**Vogle Electric Generating Plant Units 1 and 2  
License Amendment Request to Revise Technical Specification (TS)  
Sections 5.5.9, "Steam Generator (SG) Program" and TS 5.6.10,  
"Steam Generator Tube Inspection Report" for Interim Alternate Repair Criterion**

**Westinghouse Electric Company LLC, LTR-CDME-08-043 NP-Attachment, "Response to  
NRC Request for Additional Information Relating to LTR-CDME-08-11 NP-Attachment,"  
dated March 18, 2008**

**Response to NRC Request for Additional Information Relating to  
LTR-CDME-08-11 NP-Attachment**

**QUESTIONS RELATING TO STEAM GENERATOR TUBESHEET  
AMENDMENT ON INTERIM ALTERNATE REPAIR CRITERIA**

Figure 11-3: Tube Crack Geometry

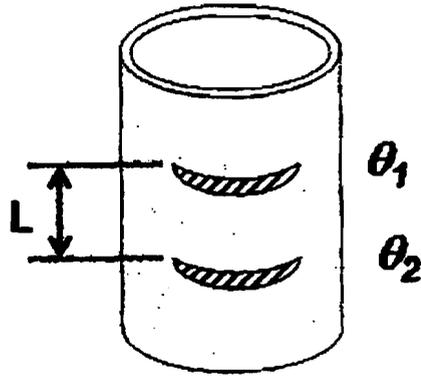
11. *The proposed tube and weld repair criteria do not address interaction effects of multiple circumferential flaws which may be in close proximity (e.g., axial separation of one or two tube diameters). Address this concern and identify any revisions which may be needed to the alternate tube repair criteria and the maximum acceptable weld flaw size.*

The impact of the crack separation analysis is summarized below. Refer to Figures 11-3 through 11-5 for explanations of the crack geometries and combinations of crack-like indications considered in the analysis. Table 11-1 is a summary of the text description of the crack separation analysis impacts. The details described in Table 11-1 apply only to the portion of the tube within the tubesheet 17 inches below the top of the tubesheet (TTS-17 inches).

1. If any circumferential crack-like indication in the tube exceeds 203°, plug the tube.
2. If there is more than one circumferential crack-like indication in a tube, and no single crack angle exceeds 203°, and the minimum axial distance of separation between the crack-like indications is

greater than or equal to 1.00 inch, then the maximum crack angle is used to describe the flaw and the tube remains in service.

3. If there is more than one circumferential crack-like indication in a tube, and no single crack angle exceeds  $203^\circ$ , and the minimum axial distance of separation between the crack-like indications is less than 1.00 inch, and the non-overlapping sum of the crack angles plus the overlapped crack angle is less than or equal to  $203^\circ$ , the tube may remain in service.
4. If there is more than one circumferential crack-like indication in a tube, and no single crack angle exceeds  $203^\circ$ , and the minimum axial distance of separation between the crack-like indications is less than 1.00 inch, and the non-overlapping sum of the crack angles plus the overlapped crack angle is greater than  $203^\circ$ , plug the tube.
